TITEL: Kontroll/modifiering av stjärtrotordrivning

LFS: 1990:26

90-17-02 ENSTROM HELICOPTER CORPORATION: Amendment 39-6688.
Docket No. 90-ASW-28.

90-17-03 ENSTROM HELICOPTER CORPORATION: Amendment 39-6686.
Docket No. 83-ASW-39.

FIGURE 1
 Tension Sides Versus Compression Sides
 Tail Rotor Drive Shaft Coupling Installation.
 Rear coupling shown; forward coupling similar.
NOTE: Tie-wraps eliminated for clarity.

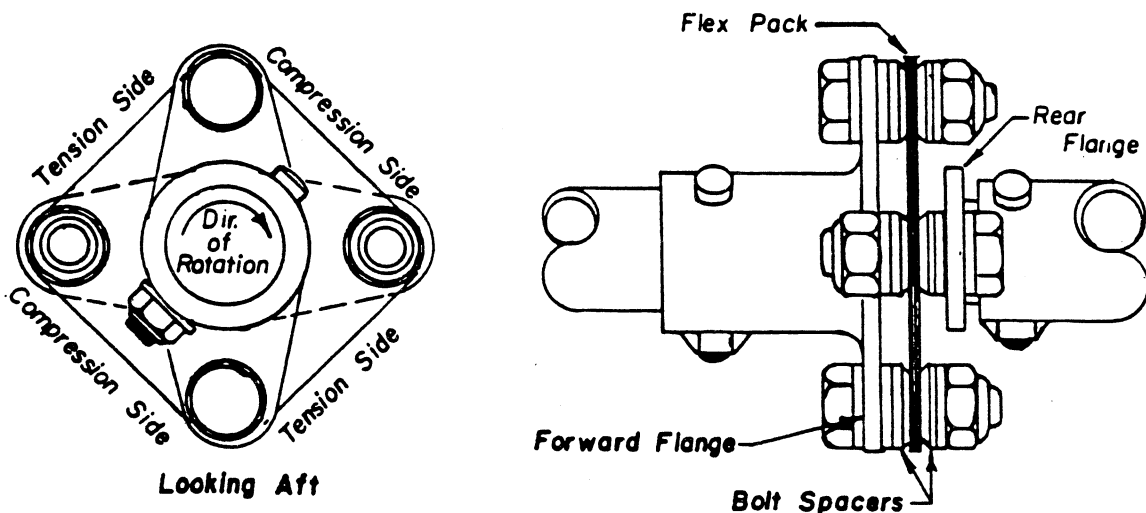
(1) Locate the tension and compression sides by comparing the couplings to Figure 1.

Figure 2 - Acceptable Limits of Bowed Flex Packs.

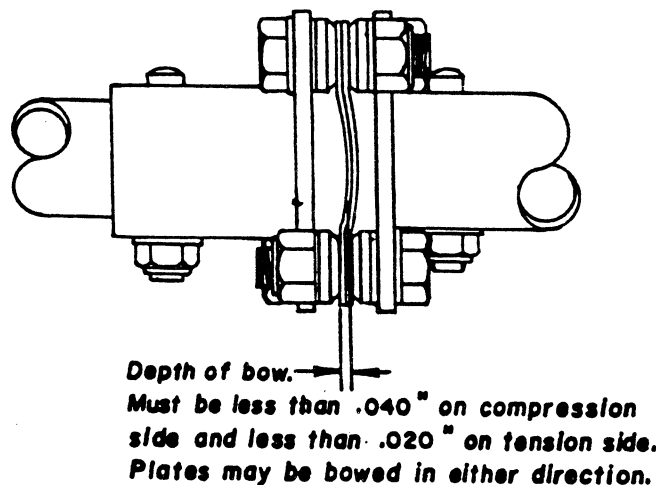
(2) Inspect the couplings for flex pack distortion in the shape of a bow. Compare any distortion to the acceptable limits shown in Figure 2.

Figure. 3 - Acceptable Limits of Flex Packs with Offset Bends.

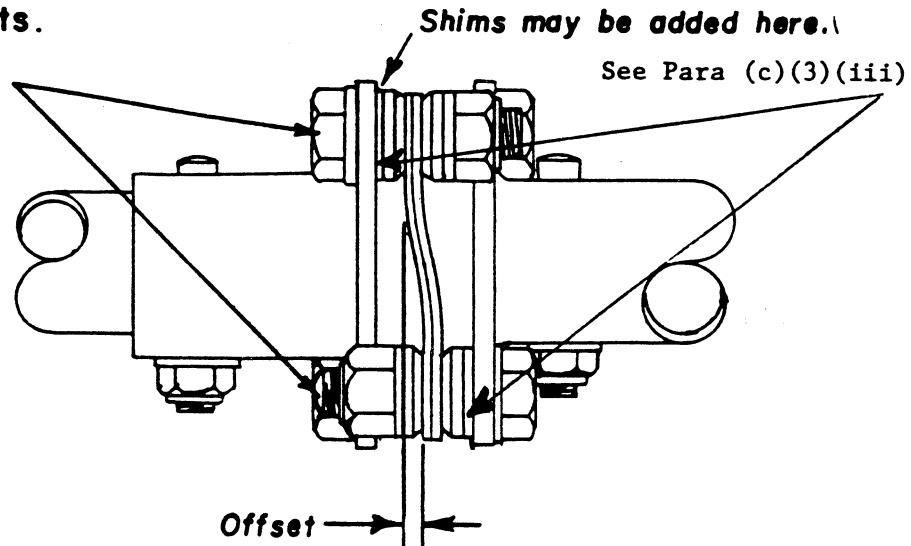
(3) Inspect the couplings for flex pack distortion in the shape of an offset bend. The acceptable limits shown in Figure 3 are as follows:

(i) The offset on one set of plates must not exceed 0.015 inches.

(ii) The maximum difference in offset from side to side (one pair of bolts to the other pair) must be less than 0.007 inches.

(iii) The maximum allowable shim thickness is 0.072 inches (not including bevel washers).

Must be less than .015" on both sides (See Para (c)(3)(i))

**.When the flex pack is replaced,
shims may be added at the bolt spacers
as indicated to align the new flex pack.**

Torque bolts to 75 in.lbs.

**CAUTION: Do not add shims or washers between
the flex pack and the beveled washers.**

Figure 1. Checking inner spline wear on coupling.

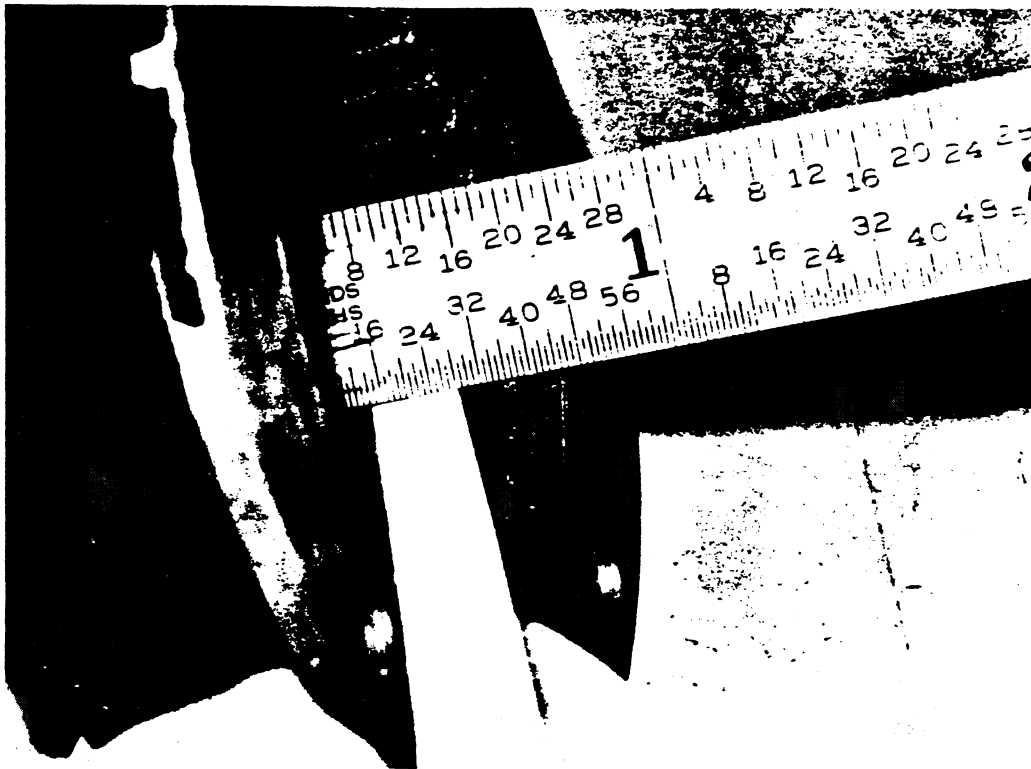
(i) Visually and dimensionally inspect for wear and proper tooth contact in accordance with Figure 1. Measure the height of the spline crown shown in Figure 2 at the center with a steel scale (having graduations of 1/100 inch) and a 10 power glass. Replace with airworthy parts any couplings that have a center crown height of less than 0.015 inch.

NOTE: Tooth wear is measured by placing a 6 inch steel rule parallel to the crown at the top edge of the driven side. A piece of .125 x .010 inch shim stock is then placed between the tooth and the rule, and pressing the rule against the tooth, check if the shim can be removed. If the shim slips out, the coupling is to be rejected and replaced with an airworthy component.

Figure 3.
Checking hardness on male
portion of coupling.

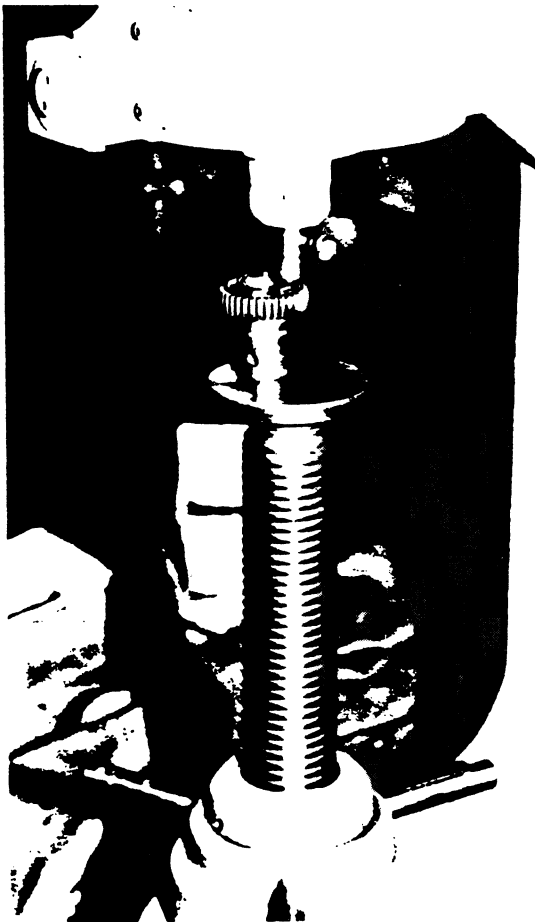
(ii) Test both the male and female portions of the coupling for material hardness. Test the male portion on the inner circular face as shown in Figure 3. Test the end of the stud of the female portion as shown in Figure 4. Use three readings and average the readings. Replace with airworthy parts any couplings which have average readings below 25 on the Rockwell "C" scale.
